UNITED STATES PATENT AND TRADEMARK OFFICE

Office Action Summary

10/607,906

KOST ET AL.

Included below is a modified figure identifying the claimed structure.

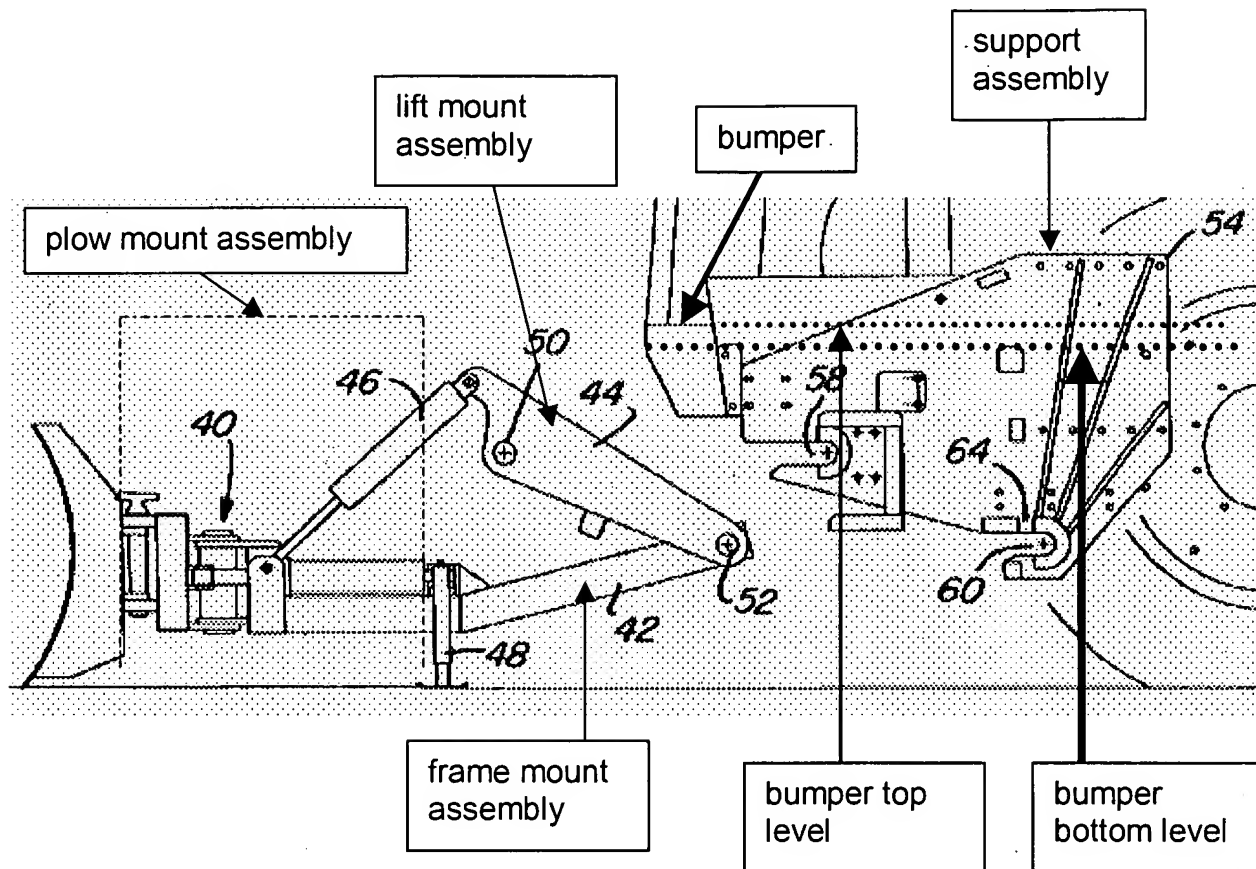
Malinowski discloses a snowplow blade mount having all of applicant's claimed structure including a frame mount assembly (including 42), a lift mount assembly (including 44), a support assembly (including members 54) having a connection end (including 58), and a plow mount assembly (considered the structure that connects the plow blade to the frame mount assembly and lift mount assembly), with the plow mount assembly detachably connected to the support assembly and including a leg support 48 as shown in figure 7. It is noted that latch bars 50 & 52 are considered removable pins since they are removable from sockets 58 & 60. It is noted that the entrance structure of sockets 58 & 60 are considered guide sections and landings, with the outermost edge being considered the guide section (see figure 7). It is noted that since the lift mount assembly is connected to cylinder 46 and the frame mount assembly by a pinned

connection, it is considered to be detachably connected. Additionally, member 48 is considered a skid plate.

Applicant's arguments filed 9/23/05 have been fully considered. Applicant's arguments regarding Behrens are persuasive however applicant's arguments regarding Malinowski are not persuasive. Applicant's overview of the invention and claims (pages 38-43) is acknowledged. Applicant argues that claims 88 and 114 require the frame mount assembly to be connected to the frame of the vehicle such that no portion of the frame mount assembly connects to the front bumper of the vehicle, extends beyond the front bumper and connects to the sides of the vehicle. First, applicant claims the subcombination of the mount assembly that is "mountable" to a vehicle, and does not positively claim the mount assembly being mounted to a vehicle. Additionally, when the snowplow blade of Malinowski is mounted to the vehicle, the frame mount assembly as set forth by the examiner does not connect directly to the vehicle bumper or side of the vehicle, and does not extend beyond the front bumper (see fig. 8). Applicant argues that the frame mount assembly includes a plurality of connectors that connect the support mount assembly to the frame mount assembly. This limitation is met by pins 52. Regarding the connectors of the connection arrangement being spaced forwardly from the engagement arrangement, it is noted that the claims do not require the connection arrangement to be positioned in the frame mount assembly. Therefore, pins 50 could be considered to be part of the connection arrangement.

Applicant argues that the plow mount assembly designated by the examiner does not have one end connectable to the support assembly. First, it is noted that applicant does not claim that the plow mount assembly is positively connected to the support

assembly, only that the plow mount assembly is "connectable" to the support assembly. Secondly, two things can be connected to each other by way of their common connection to something else. *Kreis AG v. American Hospital Supply Corp.* (DC NIII) 192 USPQ 585. Clearly, since the plow mount assembly is connected to the frame mount assembly, which is in turn pivotally connected to the support assembly, the plow mount assembly is pivotally connected to the support mount assembly. Additionally, it is noted that the modified figure above shows the identified plow mount assembly being spaced from the frame mount assembly.
